Re: Based on Expert Review, Recommendation to the Michigan Petroleum Pipeline Task Force that Enbridge's Line 5 in the Straits Be Shut Down and/or Stringent Measures Be Imposed Pending a Comprehensive Review by the State under Public Trust Law to Assess Alternatives that Prevent Catastrophic Harm to Our Public Trust Waters of The Great Lakes

**A COMPOSITE SUMMARY OF EXPERT COMMENT, FINDINGS, AND OPINIONS ON  
ENBRIDGE’S LINE 5 OIL PIPELINE IN THE STRAITS OF MACKINAC IN LAKE MICHIGAN**

**Compiled by James Olson, J.D., LL.M. and Liz Kirkwood, J.D.**

Figure 2. Safety Factor Based on Yield Strength with a Weld Efficiency Factor of 1.0 as a Function of Support Spacing at 600 psig Maximum Allowed Pressure at 290 Feet Underwater.

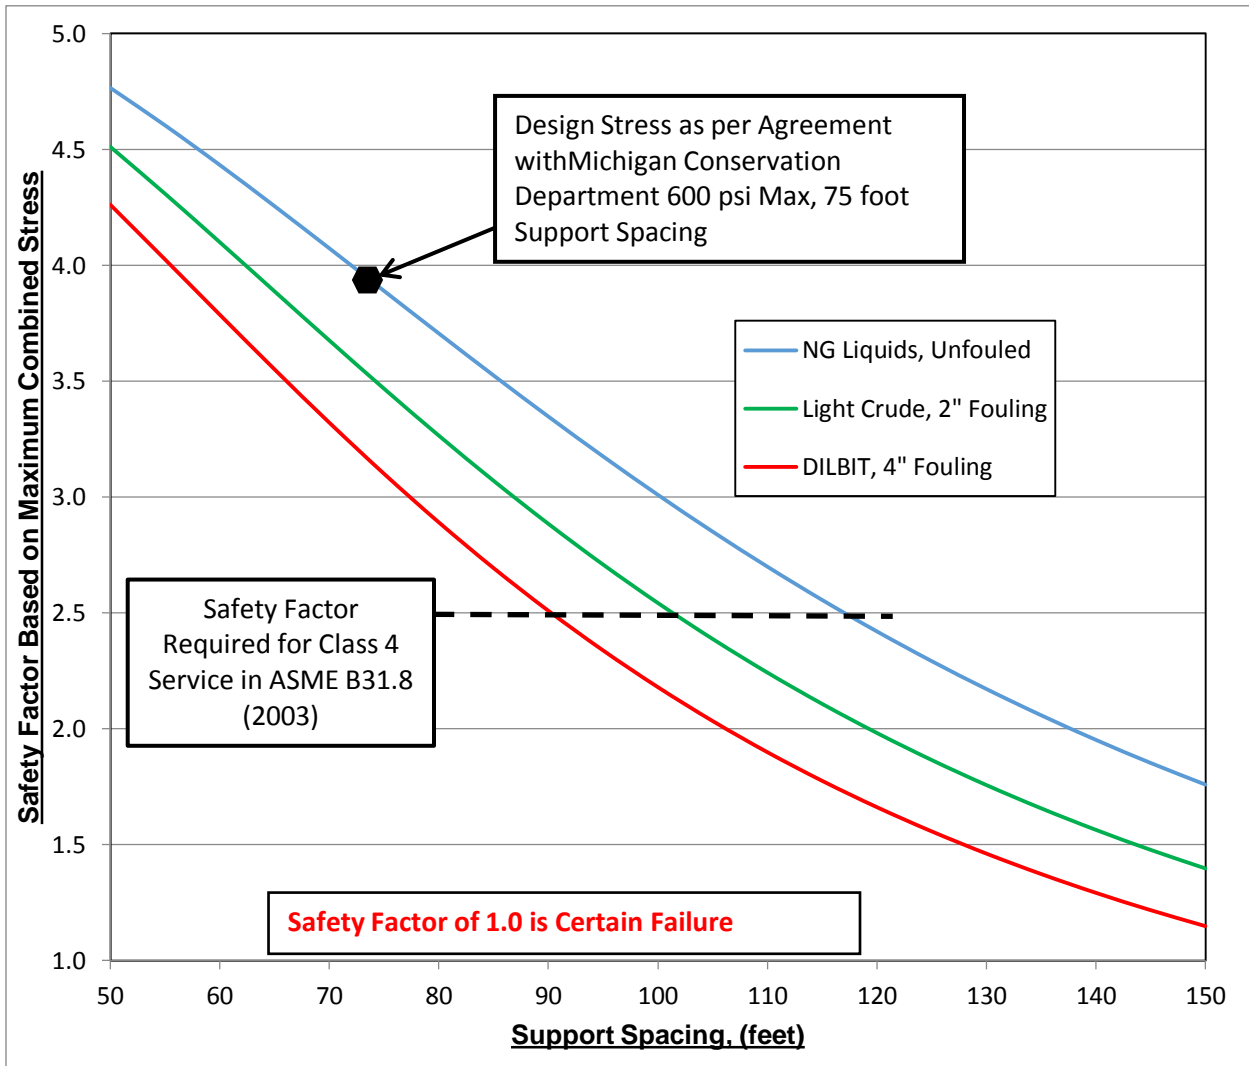
Further, based on calculated design stress per the easement and specifications for 75-foot spans in 1953, compared to calculated stresses in the changing aquatic environment and use since that time for transport of natural gas (NG) liquids (unfouled), light

The only public information on the design in 1953 of Line 5 is summarized in “Enbridge Energy Limited Partners, Operational Reliability Plan, Line 5 and Mackinac Straits Crossing.” This is not an engineering report, but appears to be a set of talking points to justify the safety of Line 5 to the Task Force and public. The document states that stress corrosion cracking “requires both a corrosive environment and high stress.” “However, neither element is present in the pipelines through the Straits, which have excellent coating at less than 25% of their design capacity.” This can be interpreted to mean that when operated at 600 psig and no more than 75-foot spans, the combined stress on Line 5 is less than 25% of the yield stress of the pipeline assuming adequate weld efficiency. This equates to the listed safety factor of 3.9 for NG liquid listed above.<sup>11</sup>

As noted above, the easement required maximum 75-foot spans. As disclosed in recent years, the maximum length of the actual spans for the pipeline under the Straits is 90 feet, which is significantly less than the specified margin of safety – only 64 percent of the required span length in the easement. More recently, Enbridge has applied for permits to install additional supports. Permits were obtained in 2014 for installation of supports every 50 feet under the GLSLA, but the DEQ did not request information related to the overall future plans, alternatives, or logistical options regarding Line 5. This should have been done so other alternatives to the old pipeline that would prevent risk to the Straits altogether.<sup>12</sup>

<sup>12</sup> Looking at the Enbridge “Operational Reliability Plan” document, above, if a 90-foot span is equal to only a 64 percent safety span distance, then the original design called for 140.6 feet, with a safety factor of only 2.0. Using this as a baseline for calculating different scenarios and circumstances and respective margins of safety, and considering reported washouts of the gravel bed, a range of unsupported spans of 90 to 120 feet may not comply with ASME B31.8. Enbridge operated the pipeline in violation of the easement, under conditions that have been unsafe. The addition of some 50-foot spans demonstrates

### EXHIBIT 5

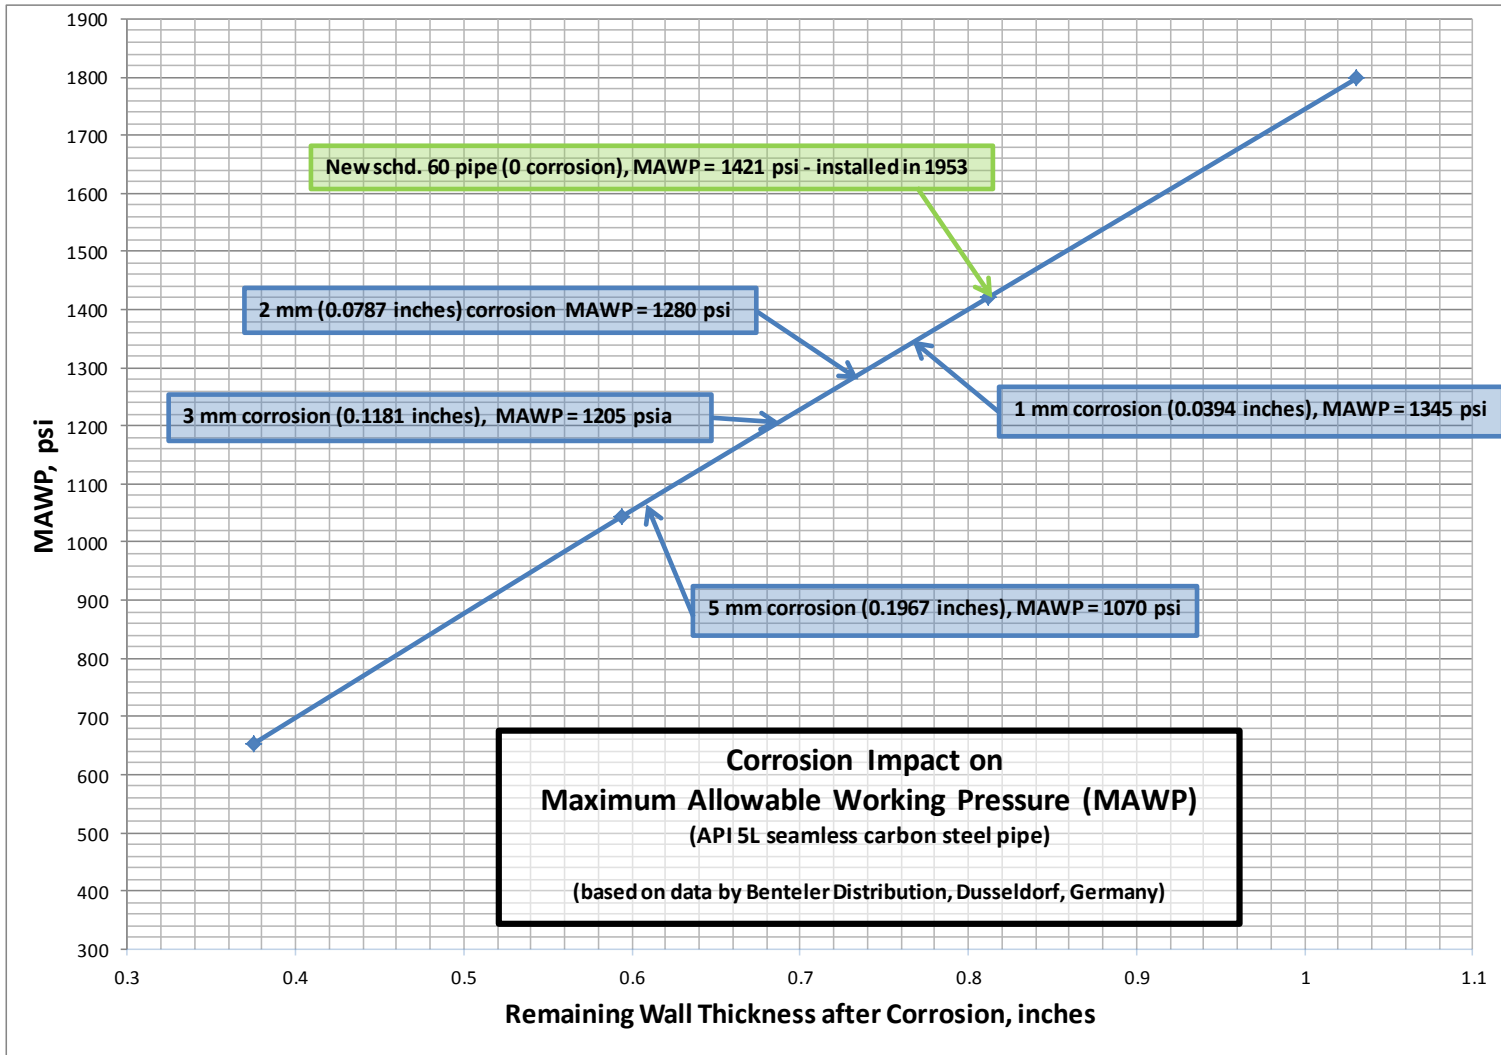
**iii. Unless Enbridge Submits a Credible Worst-Case Scenario and Its Logistical, Strategic, and Alternative and Contingent Planning Information,<sup>25</sup> and the Task Force and State Officials Expand Their Review and Decision to Achieve “Zero Risk” Through An Alternative Assessment, Line 5 Should Be Shut Down.**
